## ABBNEY PHASE 2 ROOF PLANT PROPOSALS

## 2.0 CONSENTED & PROPOSED ROOF PLANT COMPARISON

## 2.5 East Elevation Comparison

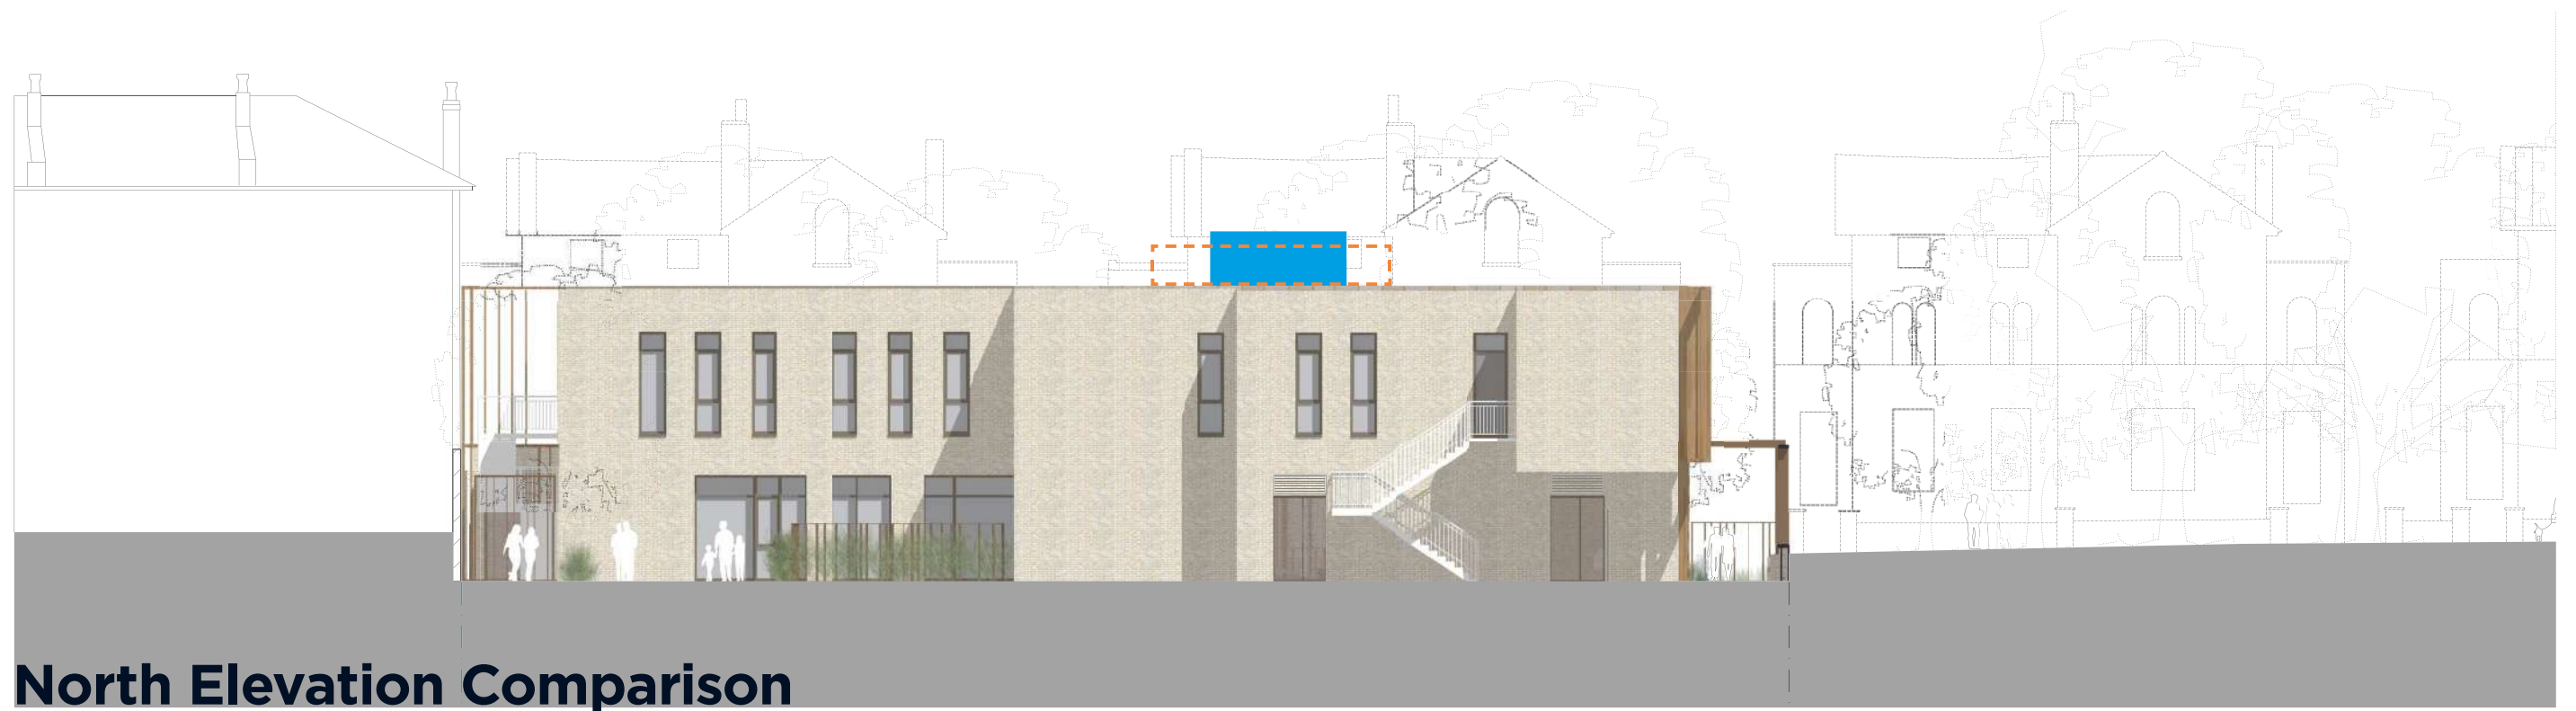
\*Please refer to final paragraph in section 1.0
